**ADDENDUM NO. 03
September 26, 2022**

**WINDSONG ELEMENTARY SCHOOL ADDITION & RENOVATION ISSUE FOUR PROPOSAL
FOR FRIENDSWOOD I.S.D.**

Prepared by: PBK
11 Greenway Plaza, 22nd Floor
Houston, TX 77046-1104
PBK Project No: 20380

A-402

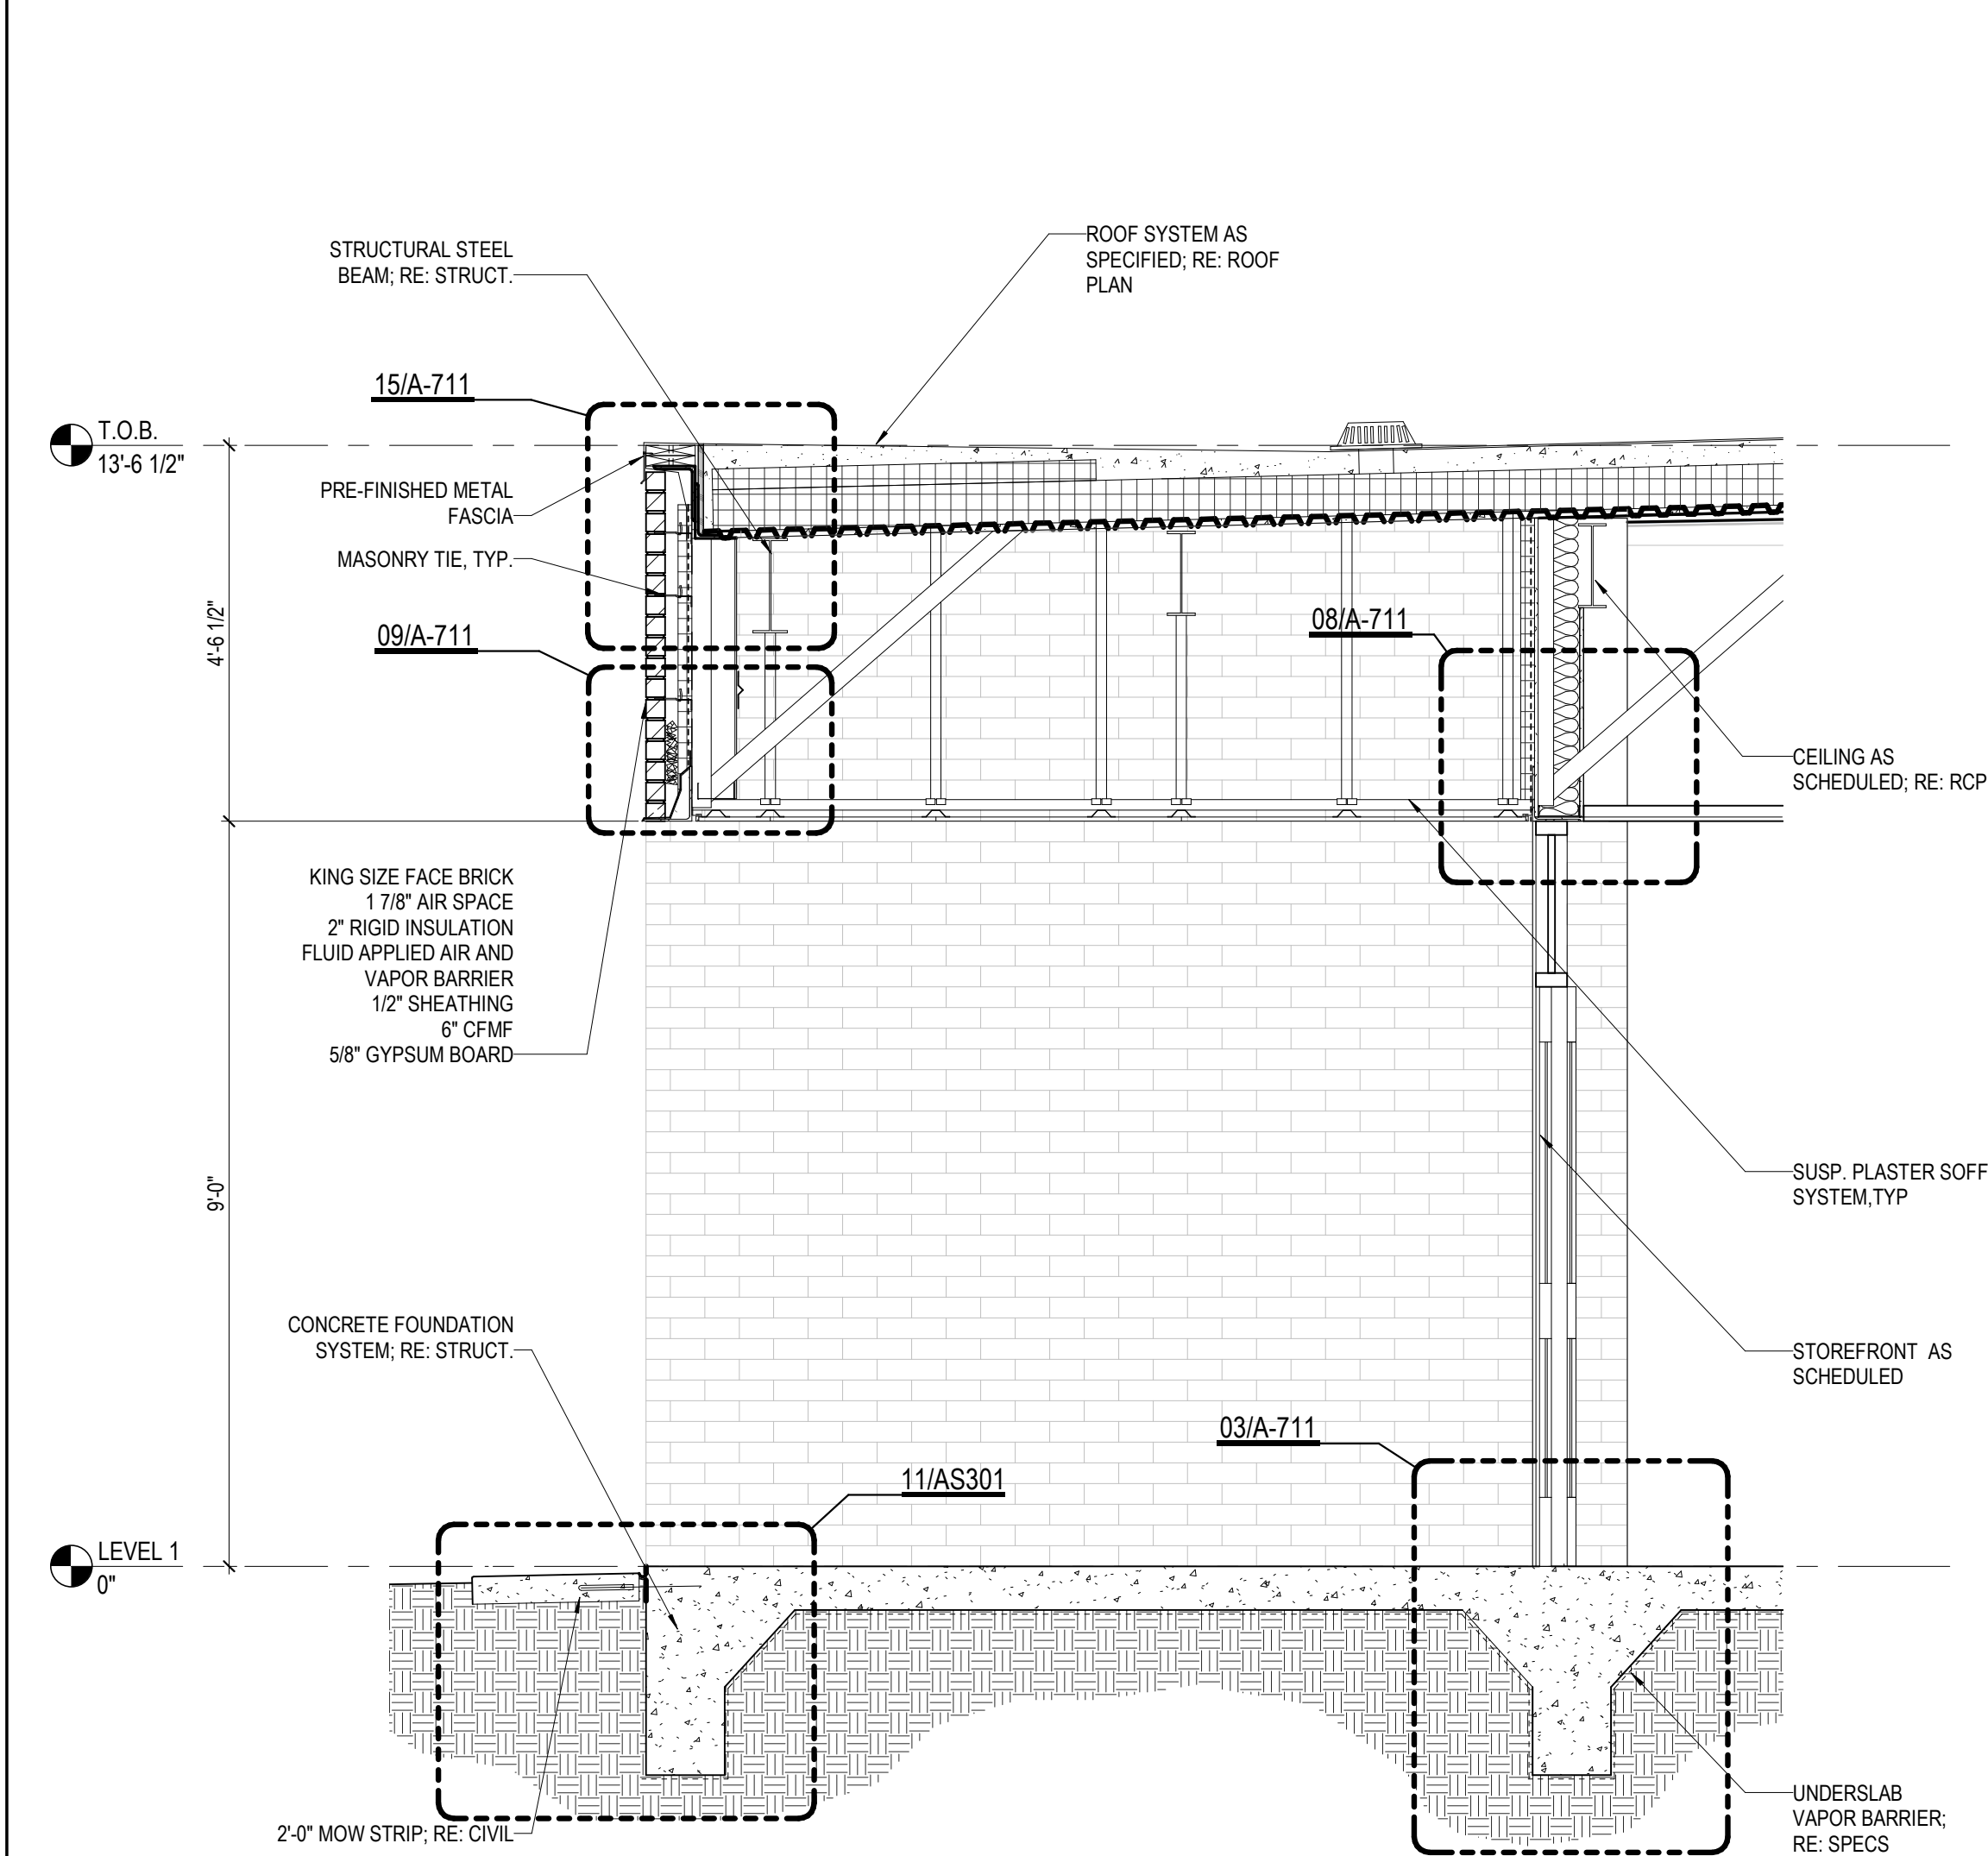
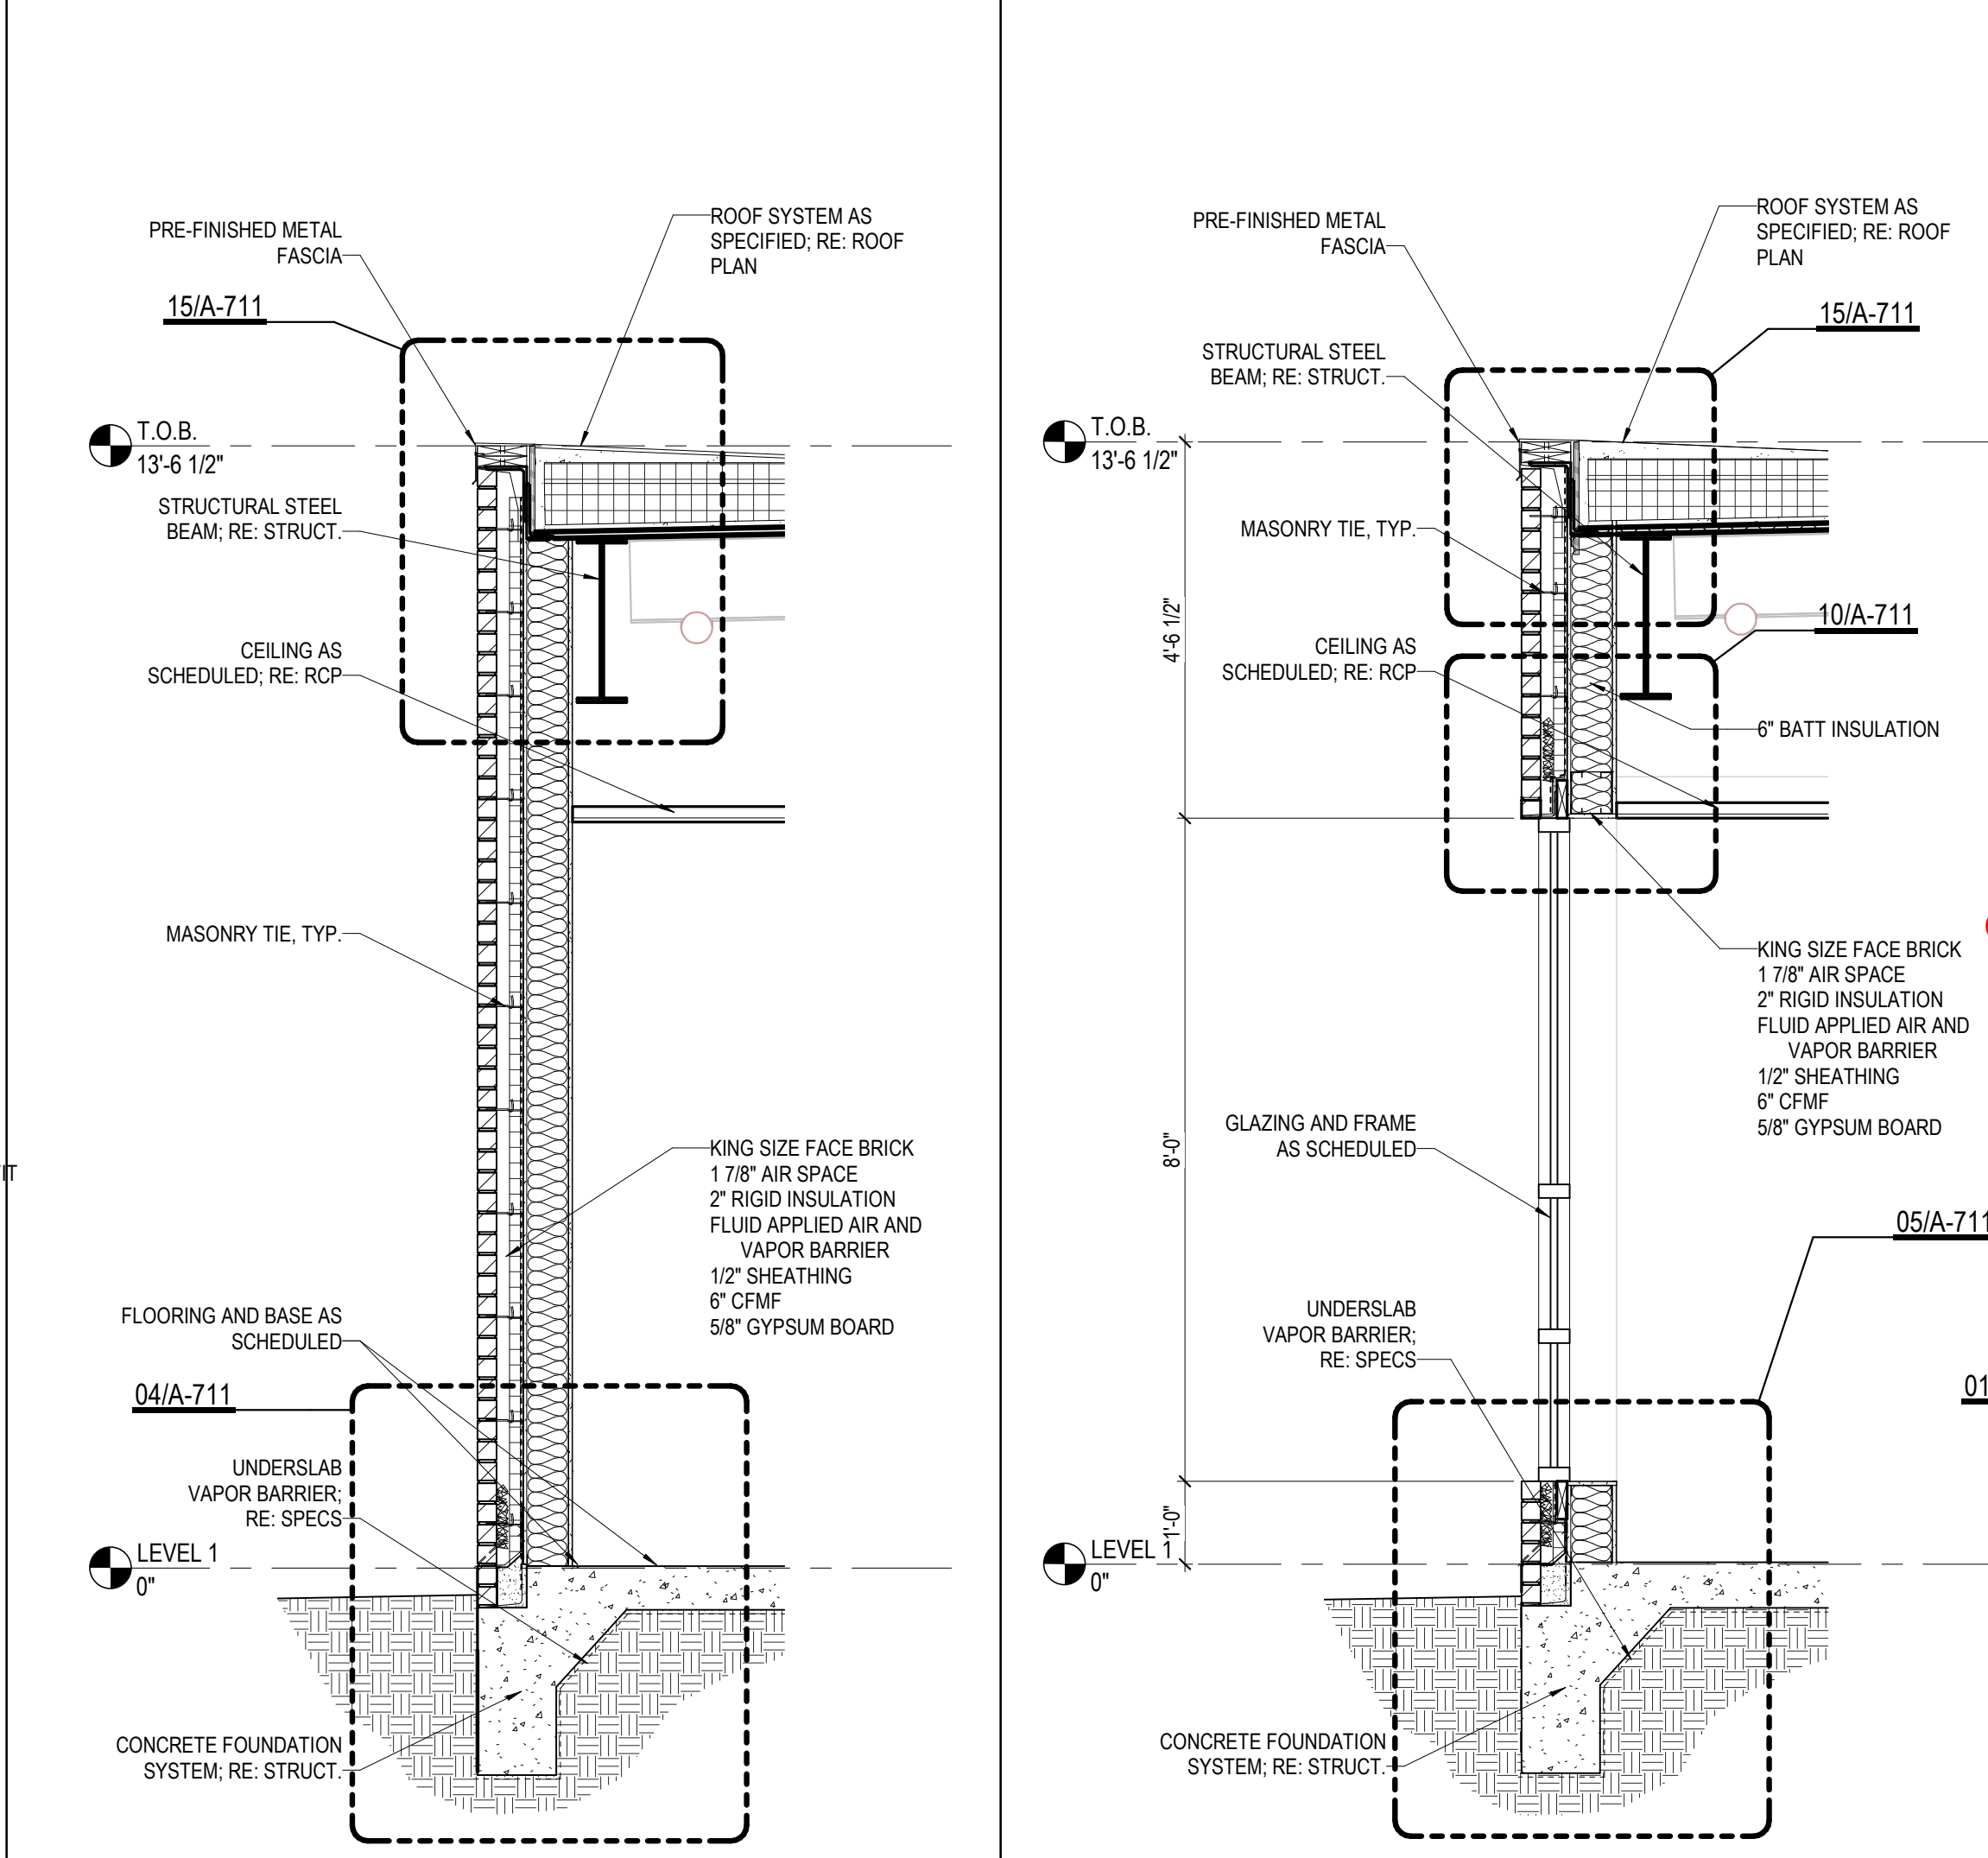
- Item No. 68 **A-402 Enlarged Interior Elevations**
 A. Detail 05: Added drinking fountain, tile, and clarifying notes, refer to attachment.
 B. Detail 08: Revised callouts for tackable surface, added corner guard callout, and revised door graphic, refer to attachment.

C. Added elevation 15 in it's entirety.
- Item No. 69 **A-602 Wall Sections:** Revised sections 01 and 06, refer to attachment.
- Item No. 70 **A-701 Plan Details**
